PROPOSED CONTRACT CHANGE

Contract No. 1252 Tunnels Date 03/01/2013
 PCC No. 1252-10 (Revision 01)
 PCC Title Relocation of TBM Retrieval Shaft

Description of PCC:

D-102

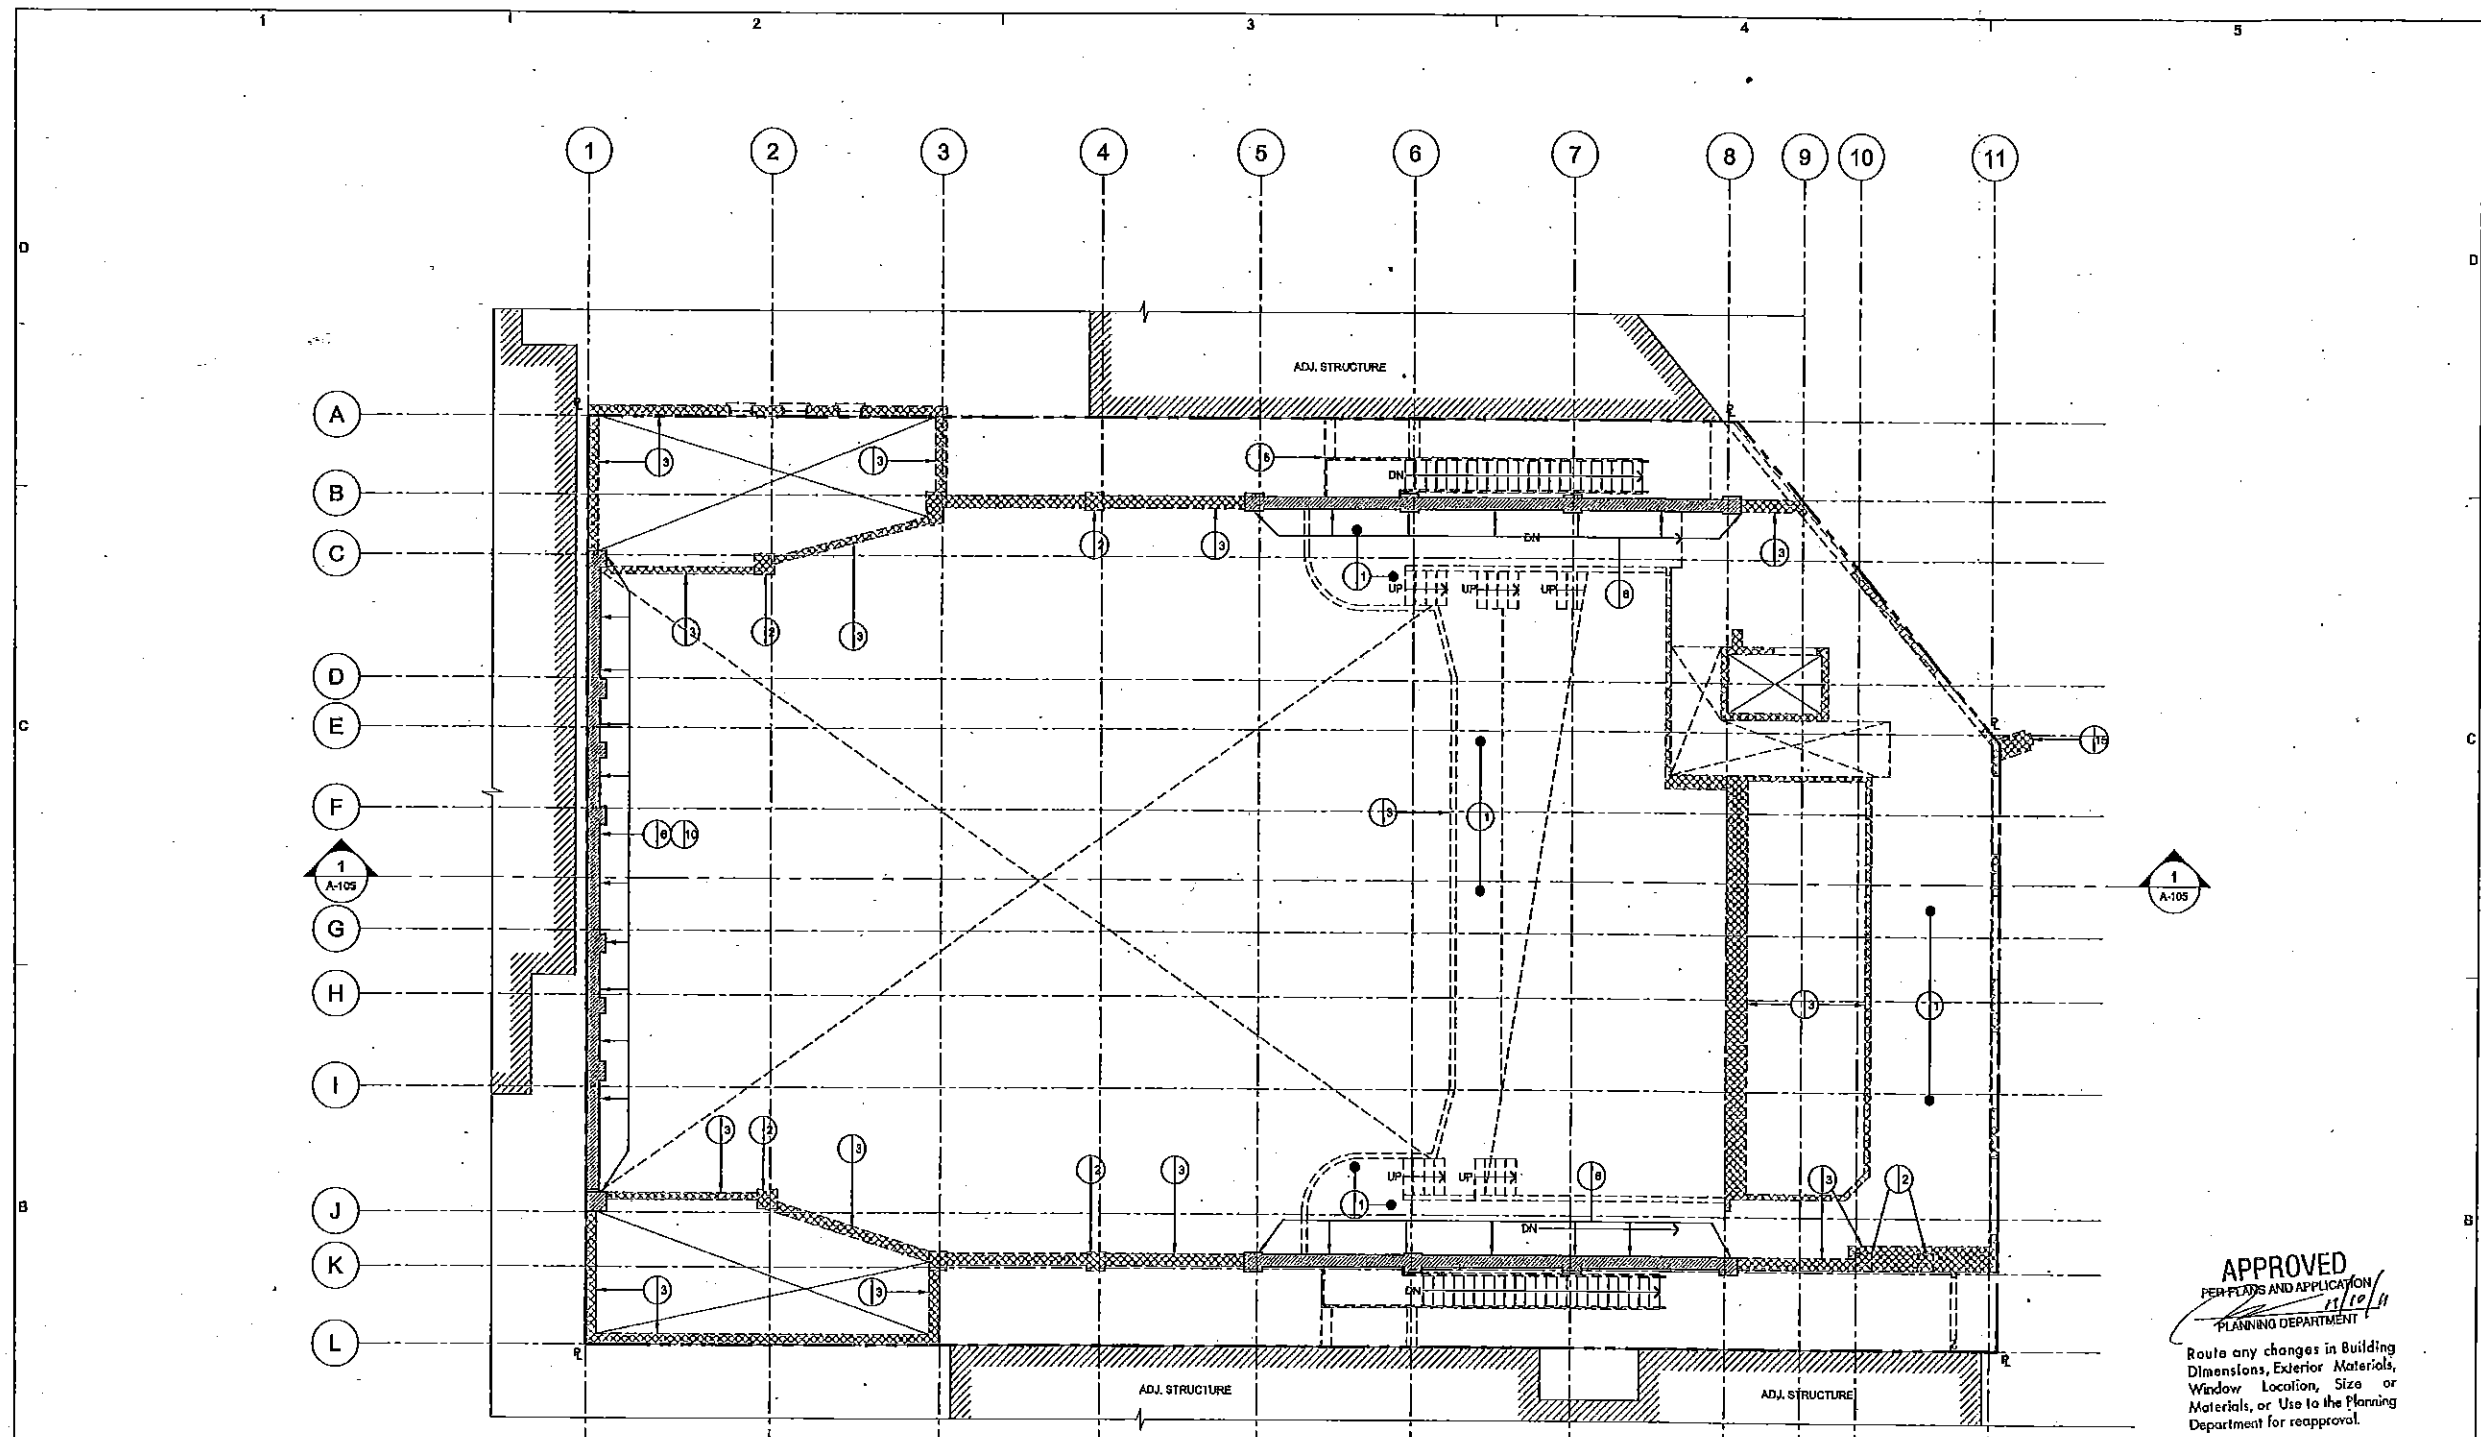
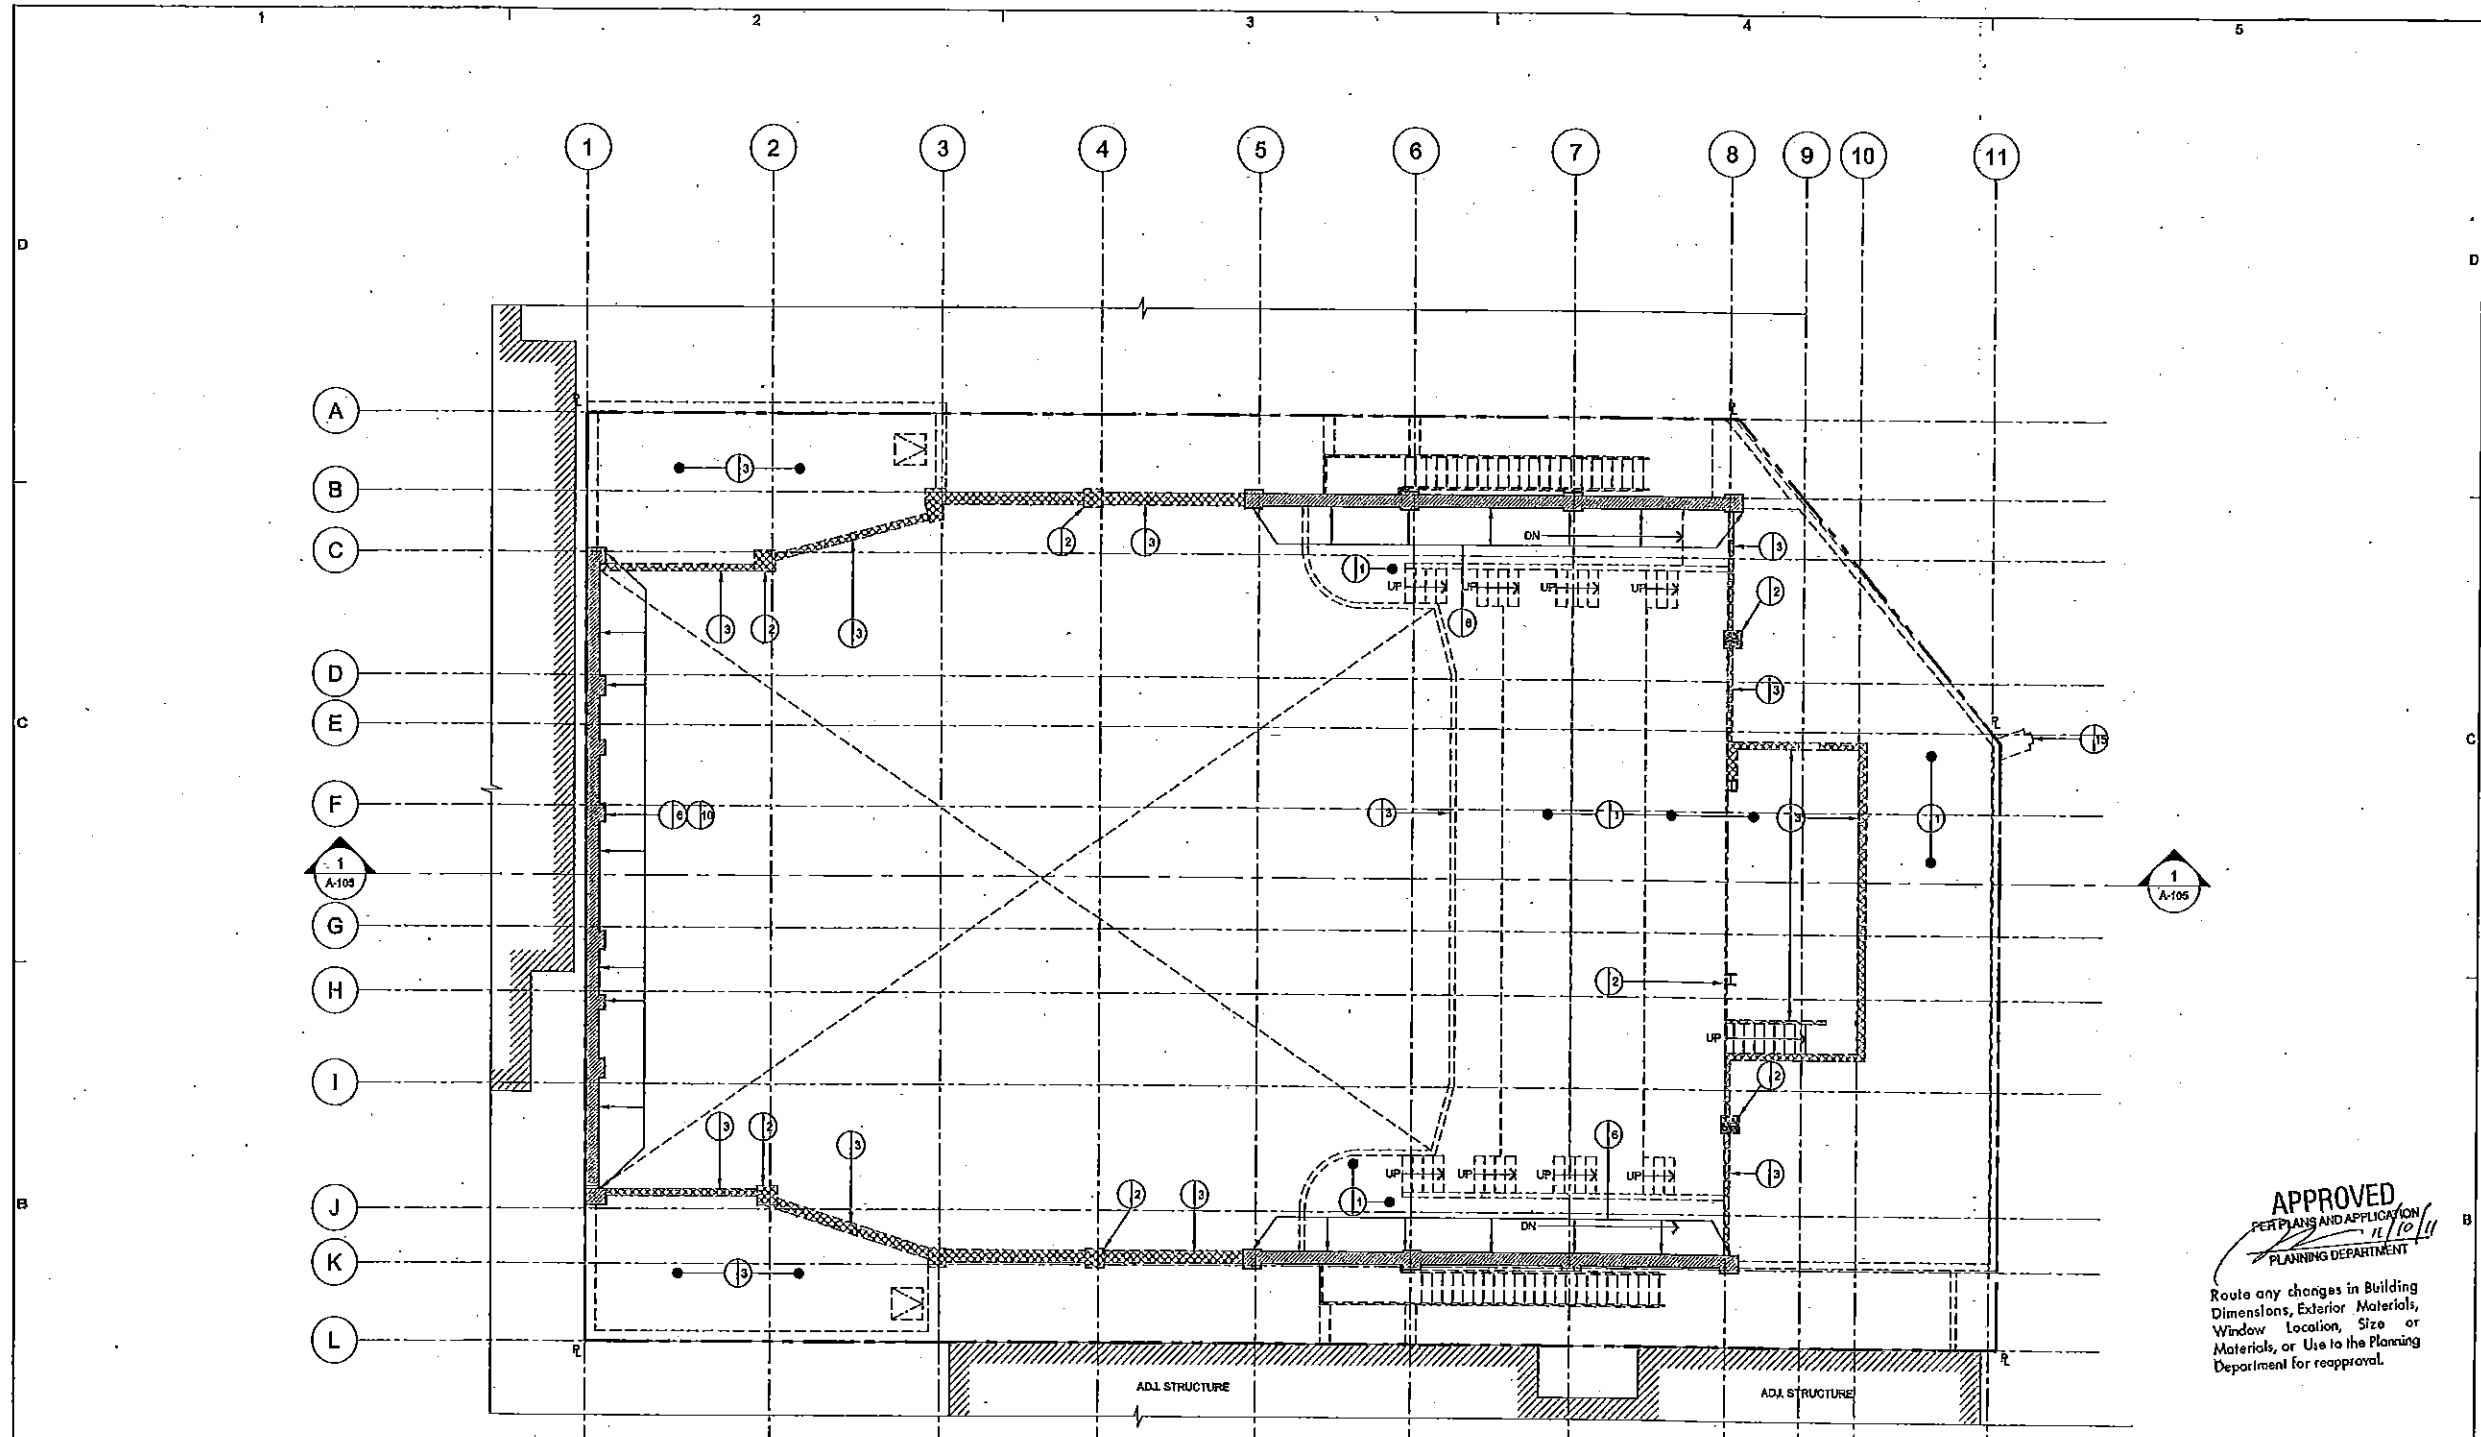
3. Design a demolition plan and demolish existing building at 1731-1741 Powell Street. Demolition to include entire building; roof trusses and perimeter walls are not to be retained as shown in the attached representative Demolition Drawings. Note: Below grade structures required for support of adjacent structures to be left in place.
